Serial Number 09/580,968

S.N. 09/580,968 GAU: 3681 Ex'r: D. Wright

AMENDED FIG. 1

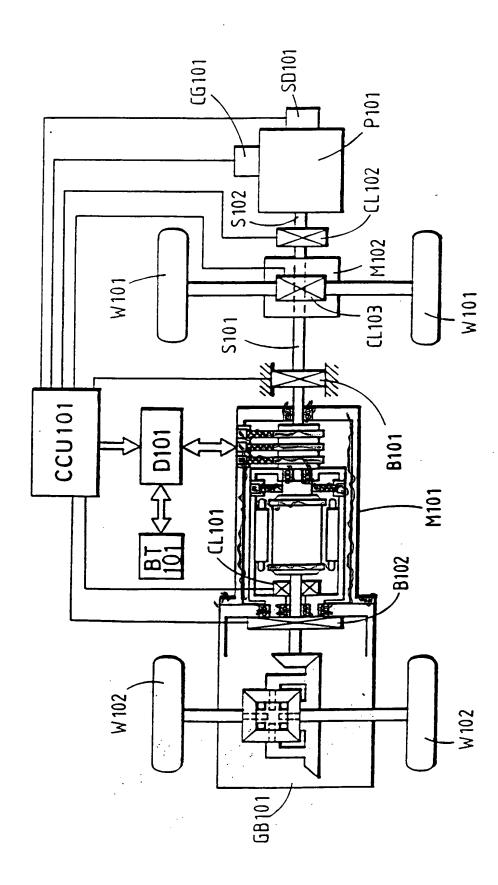
It is still believed that none of the schematically-depicted details included in these drawings represented "new matter." Nevertheless, in view of the Examiner's conclusion that the skilled in artisan would consider a depiction of a motor as having bearings to be "new matter," it is propose to delete the bearings from the drawings. In addition, in view of the Examiner's comments regarding the flange for attaching the gear box and the various brushes and conducting rings, it is proposed to delete these elements from the drawings, even though all are standard elements of the type of motor described.

Even though elements of the original amended drawings have been deleted, it is still respectfully submitted that they correct reissuable errors in the original disclosure. These errors include:

- I. failure to depict clutch CL101, a rotational field generating structure, field windings or permanent magnets on the field generating structure, and armature, which are <u>all</u> described in the specification of the patent¹ and were erroneously omitted from the drawings of U.S. Patent No. 5,547,433 (with clutch CL101 being a claimed element and therefore <u>essential</u>), and
- II. inclusion of U101 and B103, which are depicted in the original drawings but not described in the specification of U.S. Patent No. 5,547,433, and therefore were deleted in the original amended drawings.

Thus, the proposed new drawing elements correct the reissuable errors in the original drawings <u>and at the same avoid any possible new matter</u>, even under the Examiner's extremely narrow interpretation of new matter.
